This memorandum has been prepared in response to the request for staff memorandum dated January 24, 2012 in the matter of applications for transfer/new water rights No. 73811, 73834, 63-32499, 61-12095, 61-12096, 63-32703, 61-12256, and 63-33344. The following information was requested:

RE: *Response to IDWR Staff Memo regarding the sufficiency of water supply for water right applications and transfers along the I-84 corridor*

Rebuttal Report of Christian R. Petrich

In the Matter of Application for Transfer No. 73811 (Shekinah Industries); Application for Transfer No. 73834 (Orchard Ranch); Application for Permit No. 63-32499 (Mayfield Townsite); Application for Permit No. 61-12095 (Nevid-Corder); Application for Permit No. 61-12096 (Nevid); Application for Permit No. 63-32703 (Orchard Ranch); Application for Permit No. 61-12256 (Intermountain Sewer & Water); Application for Permit No. 63-33344 (ARK Properties-Mayfield Townsite) before the Idaho Department of Water Resources

Figure 5. Groundwater level change maps for the Cinder Cone CGWA for the fall season between the years (a) 1981 and 1991, (b) 1991 and 2001, (c) 2001 and 2011, and (d) 1981 and 2011.

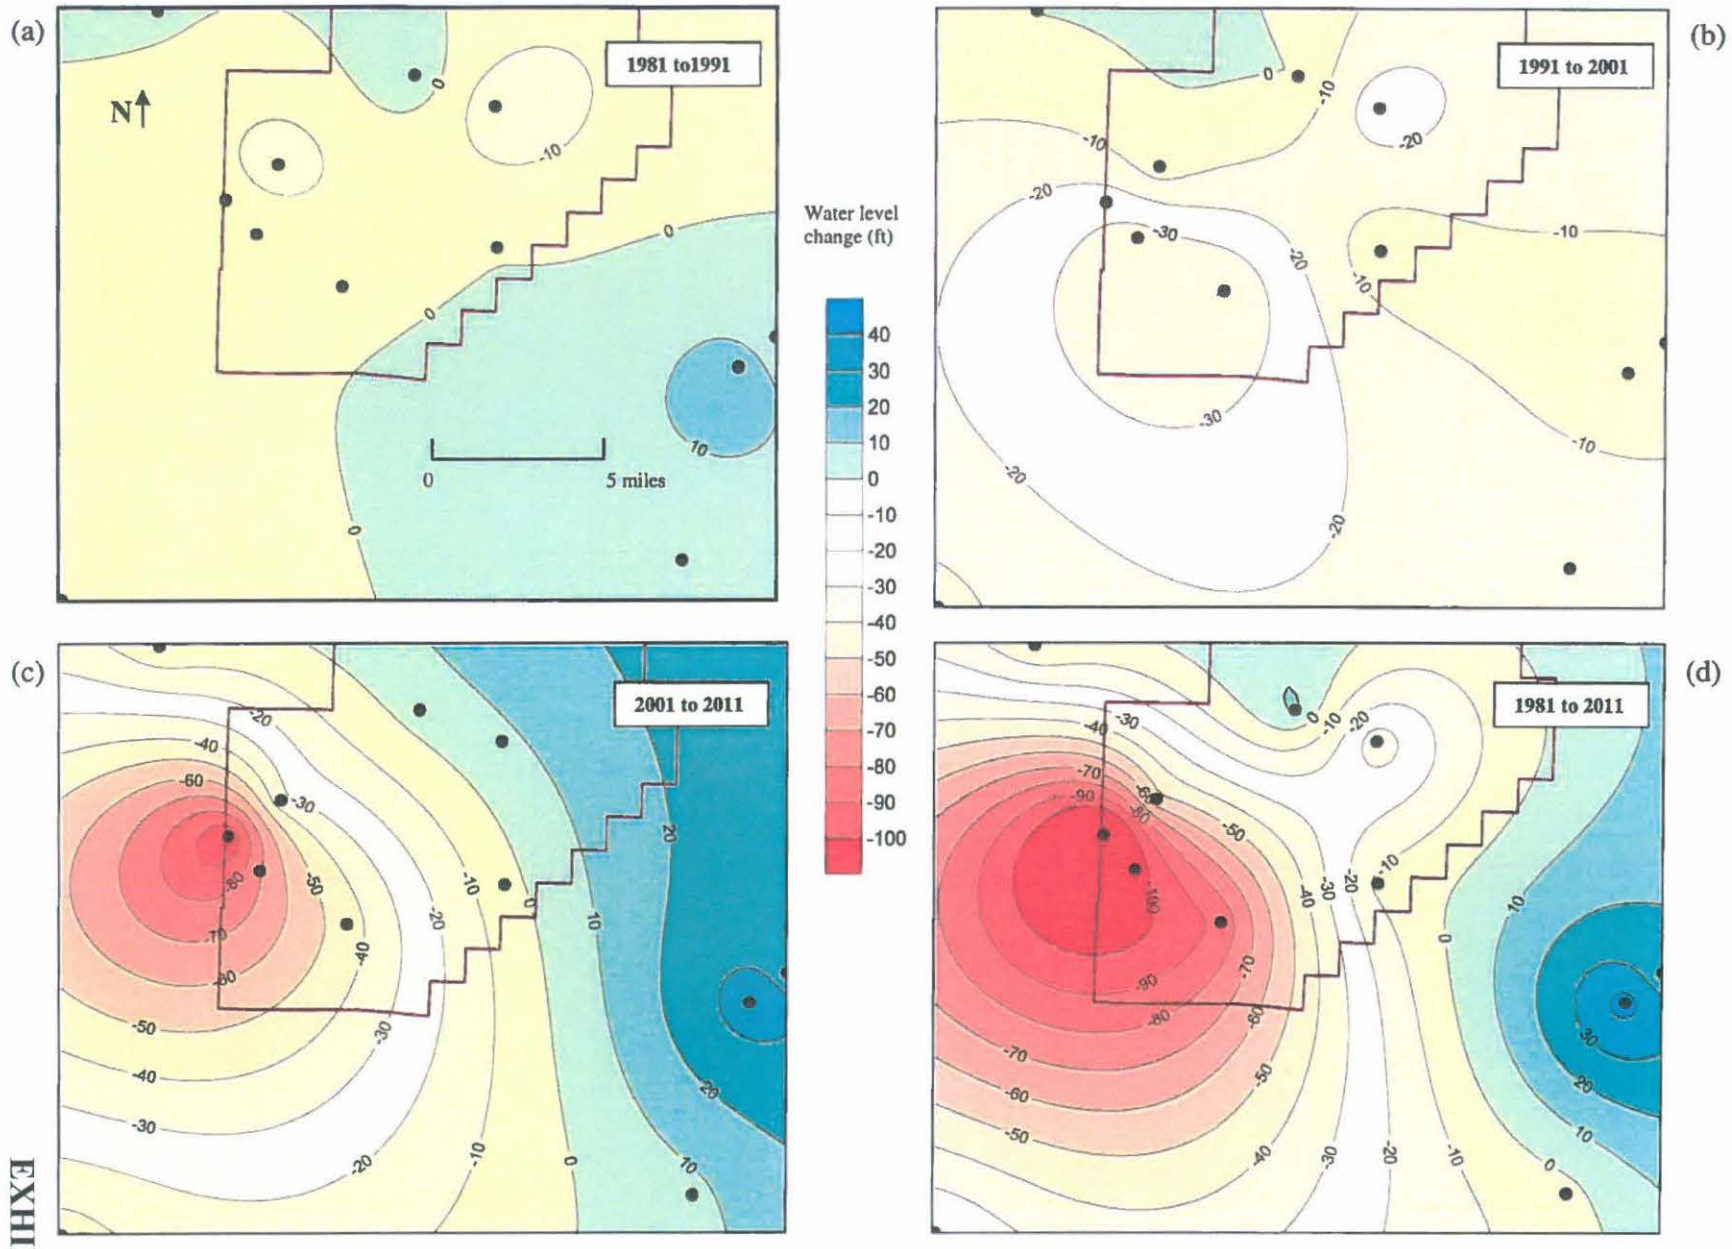
4. There clearly have been groundwater-level declines within the Cinder Cone Butte CGWA, but the degree to which water level declines within the CGWA have extended outside of the CGWA is unclear. Groundwater-level contours shown Figure 5 of the IDWR Staff Memo[8] show substantial declines extending west and southwest (i.e., outside) of the CGWA in the consolidated cases study area, but these depictions of the study-area groundwater-level declines represent a software interpolation unsupported by actual groundwater-level data.

3. ERO uses Figure 5 of the IDWR Staff Memo to suggest that a 20-mile diameter area of groundwater-level decline stemming from pumping in the Cinder Cone Butte Critical Ground Water Area (CGWA) extends substantially into the consolidated cases study area. However, the IDWR depictions of groundwater-level declines outside of the CGWA are based on software interpolation unsupported by actual groundwater-level data.

ERO's argument appears to be based on a map of purported groundwater-level declines stemming from Cinder Cone Butte CGWA pumping (see Figure 5, IDWR Staff Memo). However, the IDWR depictions of groundwater-level declines outside of the CGWA are based on software interpolation unsupported by actual groundwater-level data. Furthermore, Figure 4 of the IDWR Staff Memo also does not appear to indicate groundwater-level declines within the study area stemming from Cinder Cone Butte CGWA pumping. Thus, neither Figures 4 nor 5 of the IDWR Staff Memo support the concept of a 20-mile diameter water-level decline attributable to pumping in the Cinder Cone Butte CGWA.

Perhaps more telling is that approximately 40 years of pumping in the Cinder Cone Butte area has not resulted in the type of water-level decline projected by ERO's Theis results. IDWR Figure 5(d) suggests that there has been zero water-level decline since 1981 in the vicinity of the proposed applications and transfers as a result of Cinder Cone Butte area pumping over the past several decades. Thus, although ERO's Theis analysis might predict widespread water-level decline within the study area as a result of proposed pumping, monitoring data from actual pumping in the Cinder Cone Butte area demonstrate otherwise.

Figure 1. Cinder Cone CGWA Well Hydrographs

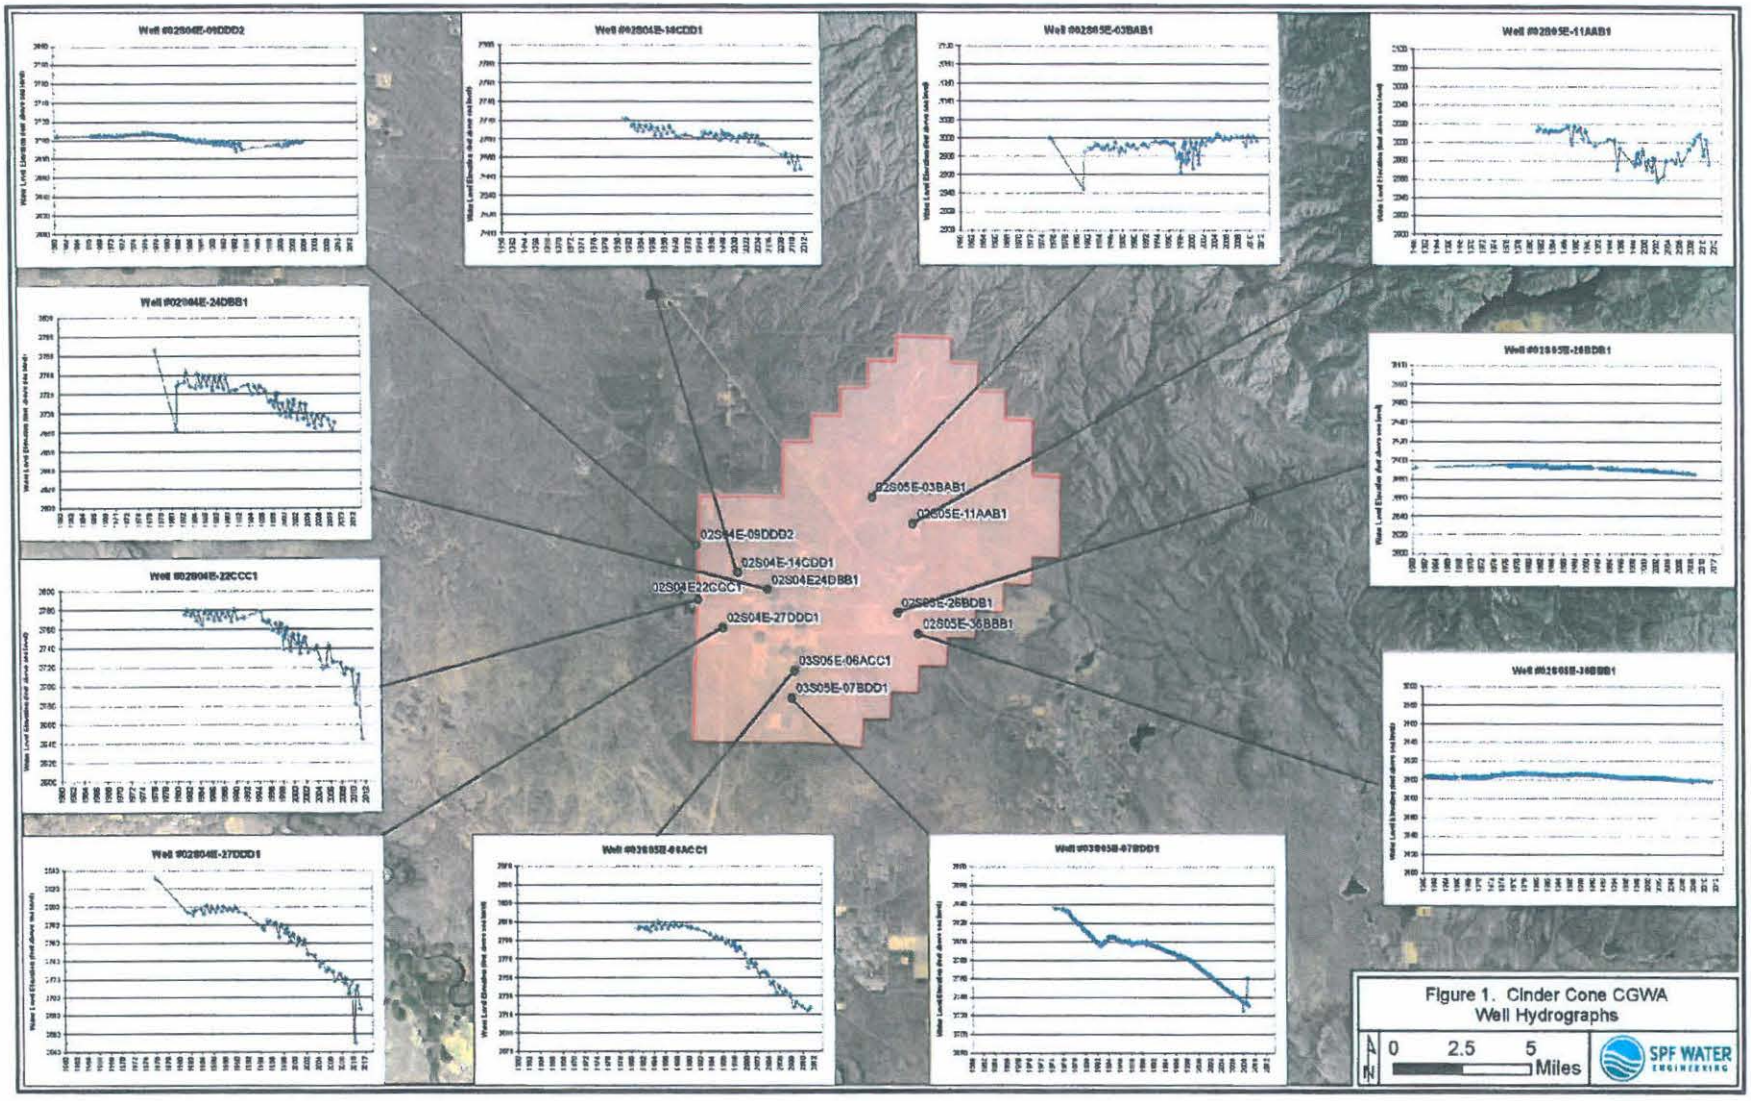
5. Hydrographs[9] in the southwestern portion of the Cinder Cone Butte CGWA show a consistent downward trend in groundwater levels. It appears that drillers' reports are available for only 6 of the 11 wells used in this analysis[10]. Some of the wells for which drillers' reports are available have very broad completion intervals (e.g., Well 02S05E-06ACC1 has an open interval of over 1,000 feet). It is not clear whether the observed water-level declines represent aquifer conditions throughout these open intervals or in individual aquifer zones.

plotted with consistent y-scales the hydrographs show that the area of greatest declines is limited to the southern portion of the CGWA (Figure 1, page 15).

Figure 1. Inferred groundwater flow directions at study-area boundaries.

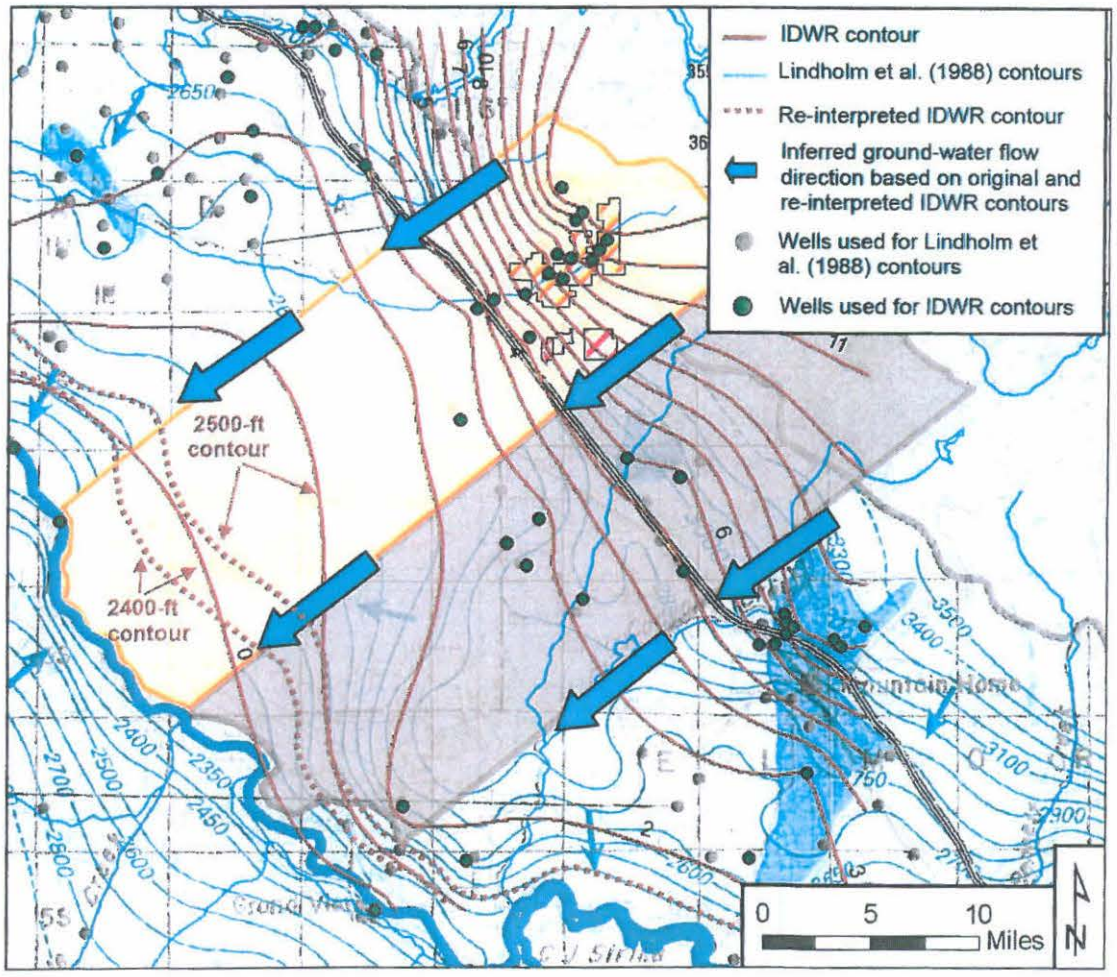
1. Contrary to ERO's assertions, the study area defined for this matter by the Idaho Department of Water Resources (IDWR) is appropriately sized and technically defensible. Constraining study-area dimensions to hydrogeologic features such as faults or geologic contacts (as ERO suggests) would require extending the study area to include the entire western Snake River Plain, an unwieldy and impractical study area for answering the specific water-budget questions at hand.

That said, the southwest-northeast study-area boundaries are not entirely perpendicular to IDWR's groundwater-level contours (see Figure 4 of the IDWR Staff Memo) in the southern portion of the study area. As such, the study boundaries appear to not be aligned along regional flow lines in this area. However, Lindholm et al. (1988) defined regional groundwater-level contours using a much larger (and more regional) data set. Figure 1 shows (a) Lindholm et al.'s groundwater-level contours, (b) IDWR groundwater-level contours presented in Figure 4 of the IDWR Staff Memo, and (c) IDWR water-level contours that SPF reinterpreted based on the previous Lindholm et al. contours. Inferred groundwater flow lines based on the IDWR contours and Lindholm et al. regional groundwater-level contours represent a reasonable basis for IDWR's southwest-northeast study-area boundaries.

Figure 7. Townships in the consolidated cases study area and adjacent comparison area.

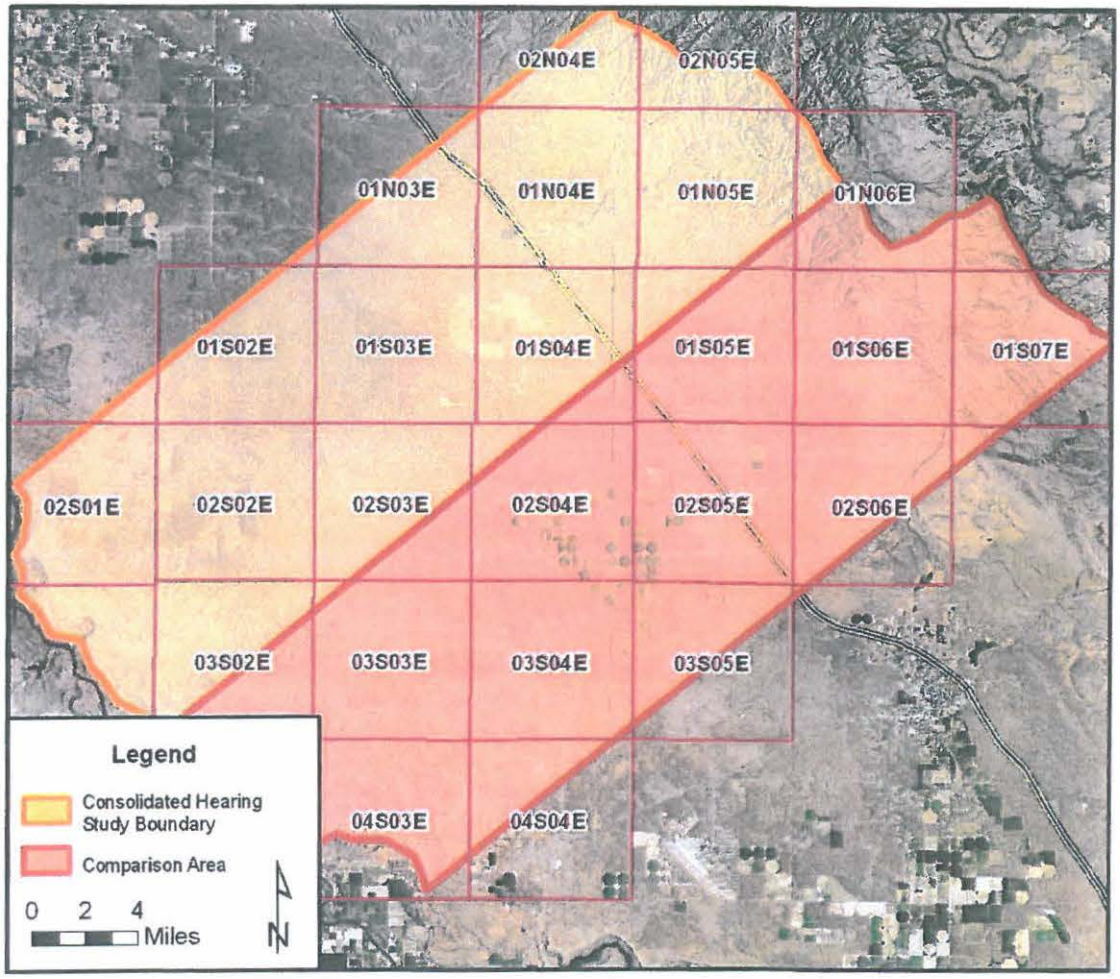
be included in the water budget. However, the wells to which ERO refers are in the Cinder Cone Butte comparison area, not the study area (see Figure 7). Lithologic descriptions from these Cinder Cone Butte CGWA wells do not adequately describe stratigraphy in the consolidated cases study area.

Figure 8. Portion of "non-recharge area" from which recharge capture is likely.

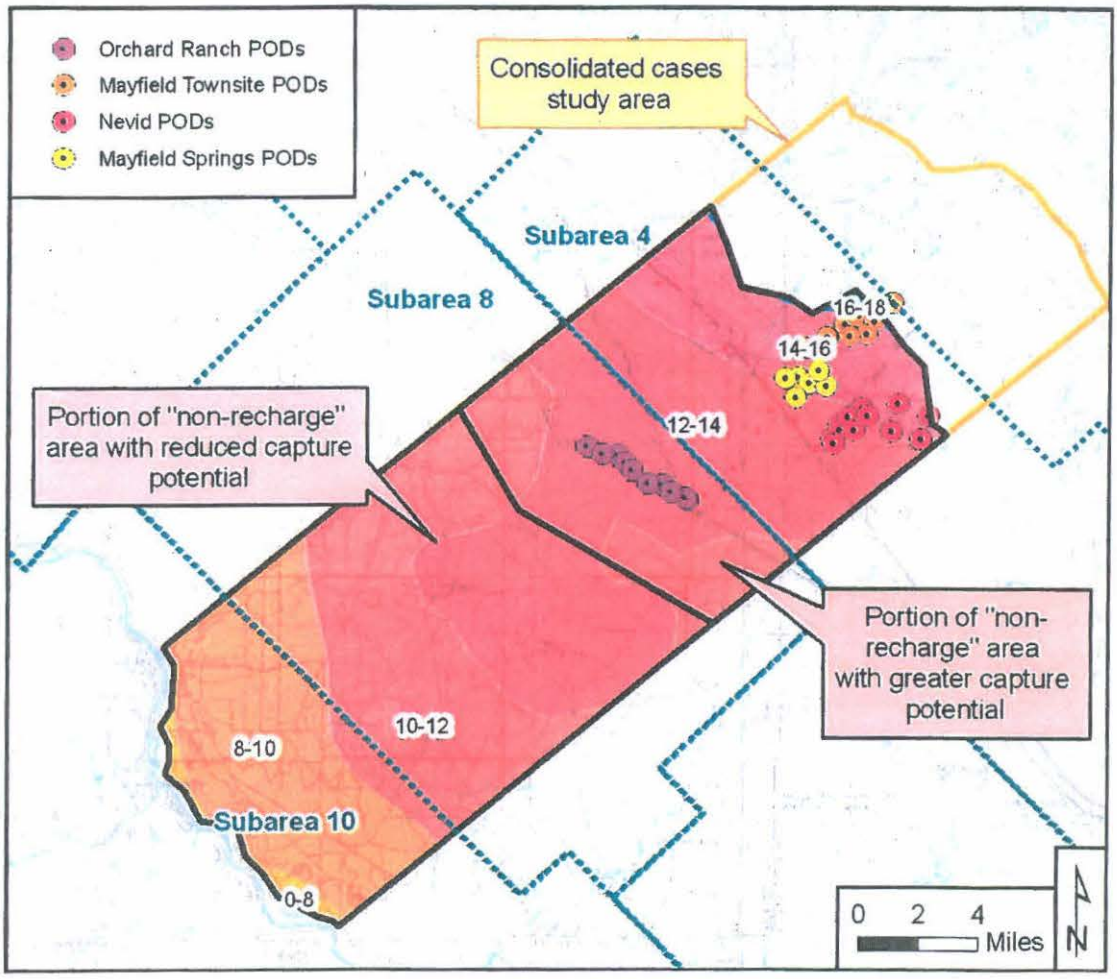
Figure 8 illustrates a portion of the "non-recharge" area with greater potential of capturing recharge originating from the "non-recharge" area and an area with reduced capture potential. The line separating these two portions of the "non-recharge" area is approximately 3 miles down-gradient of the Orchard Ranch wells, which presumably could develop an approximate 3-mile capture radius.

Figure 9. Comparison of Newton (1991) model zone locations interpreted by IDWR and SPF.

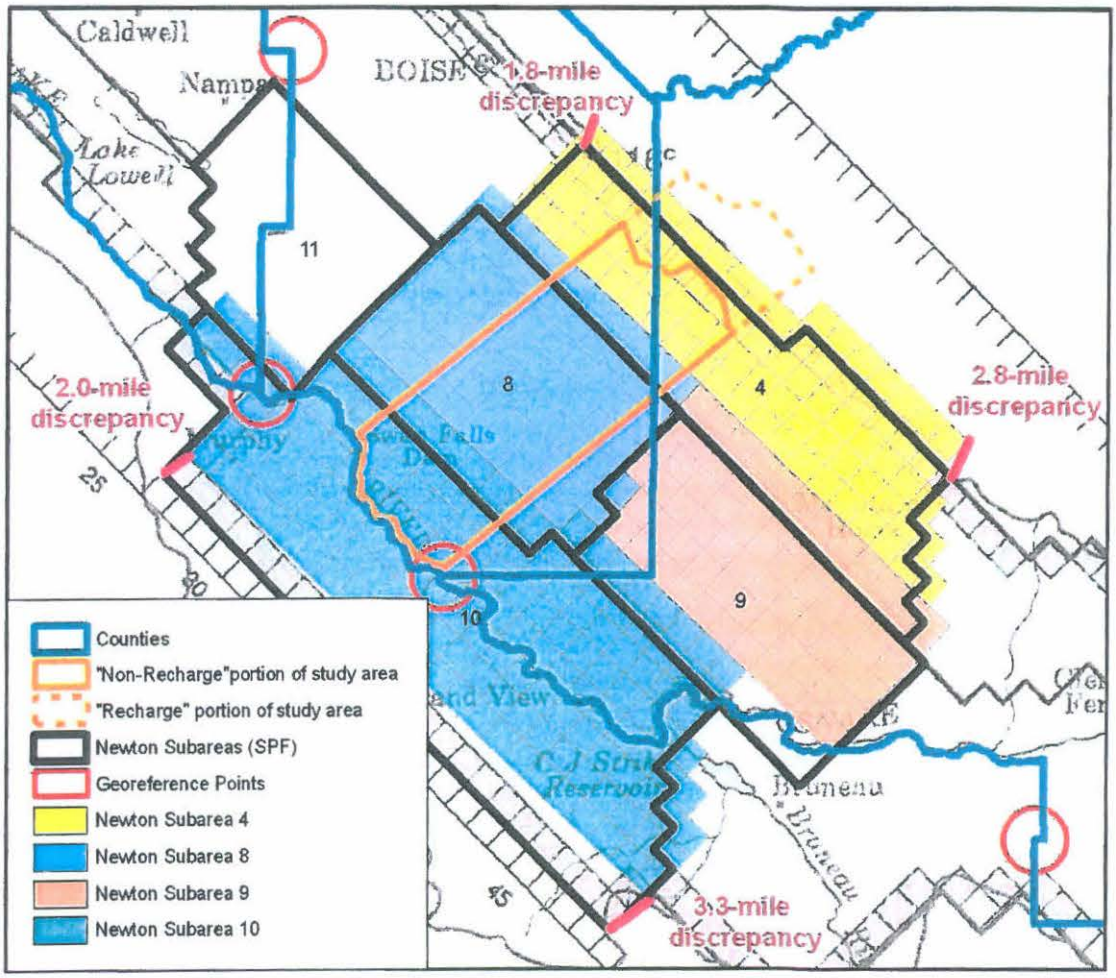
The geo-referencing discrepancy is illustrated in Figure 9. SPF scanned Figure 17 in the Newton (1991) report and geo-referenced this map using county shapefile polylines (6 points) as reference points. IDWR's geo-referencing was off by distances

of 1.8 to 3.3 miles at four representative corner points (Figure 9). Examples of SPF's geo-referencing points are shown in Figure 10. The net result is that there is a larger portion of USGS subarea 4 and a smaller portion of Subarea 10 in the consolidated cases study area than calculated by IDWR.
